**City of Pompano Beach, Purchasing Division
1190 N.E. 3rd Avenue, Building C
Pompano Beach, Florida, 33060**

**ADDENDUM #4, BID H-23-12
REHABILITATION OF WASTEWATER PUMP STATION NO. 65**

DWG No. E.3.0

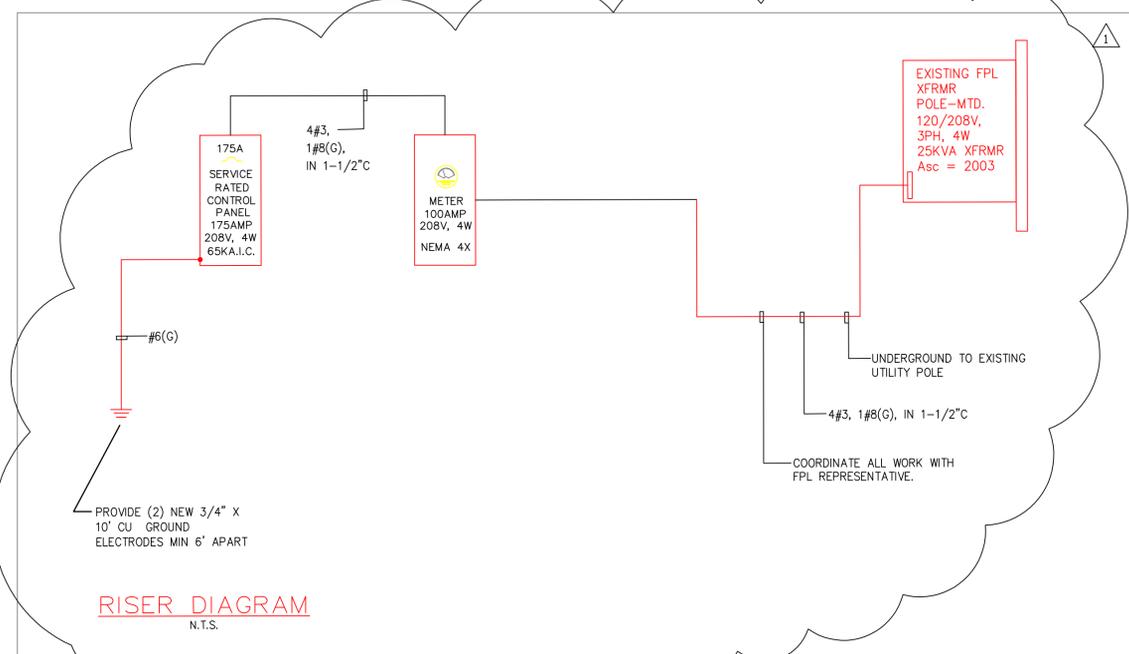
- Q21: Drawing E.3 also indicates install a disconnect before the meter. If the power is FPL they won't allow a disconnect before the meter.
- A21: Code requires a meter disconnect to be installed ahead of the meter to interrupt service for meter maintenance on 480v services and above. This is not considered the primary service disconnect. This would only be required on LS-81 and not LS-65.

E3.0 on #65, revised electrical riser and notes on site plans
